Access Compliance Report

Public Rights-of-Way

Intersection ID: 32284	Main Street: LANDING_PLACE_LN	Cross Street: STEWARTS_BEND_LN	Location: SE
ADA ID: 54A1B68C0850	Ramp Type: PerpDiag	Initial Pass/Fail: Fail	Overall Compliance: No
		Severity Score: 10

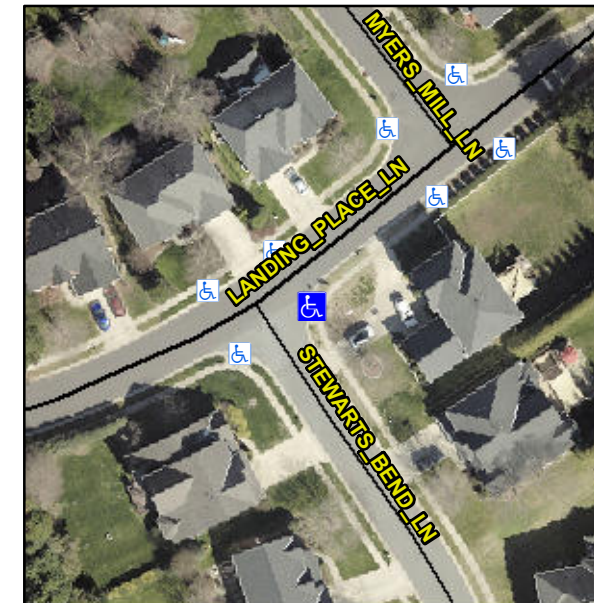
Not Found, R304.5.1, R304.5.3

Compliance	Description	Data	Compliance	Description	Data
N/A	Ramp Length (in)	47.5	Yes	Ramp Slope (%)	7.3
No	Ramp Width (in)	40.0	No	Ramp XSlope (%)	4.9
N/A	Flare Type LT	N/A	N/A	Flare Type RT	N/A
N/A	Flare Slope LT (%)	N/A	N/A	Flare Slope RT (%)	N/A
N/A	Flare Traversable LT?	N/A	N/A	Flare Traversable RT?	N/A
N/A	Landing Length (in)	N/A	N/A	DWS Provided?	N/A
N/A	Landing Width (in)	N/A	N/A	DWS Contrast?	N/A
N/A	Landing Slope (%)	N/A	N/A	DWS Length (in)	N/A
N/A	Landing X Slope (%)	N/A	N/A	DWS Full Width?	N/A
N/A	Landing Curb? (Y/N)	N/A	N/A	DWS Offset (in)	N/A
N/A	Shared Landing?	N/A			
N/A	Gutter Ponding?	N/A	N/A	Gutter Slope (%)	N/A
N/A	Gutter Lip Ht (in)	N/A	N/A	Gutter X Slope (%)	N/A
N/A	Painted X Walk1?	No	N/A	Painted X Walk2?	No
	X Walk 1 Direction	To NW		X Walk 2 Direction	To SW
N/A	X Walk 1 Width (in)	N/A	N/A	X Walk 2 Width (in)	N/A
	X Walk 1 Slope (%)	4.8		X Walk 2 Slope (%)	2.3
	X Walk 1 X Slope (%)	0.5		X Walk 2 X Slope (%)	5.9

Remove & Replace Curb Ramp With Two New Directional Ramps or Equivalent.
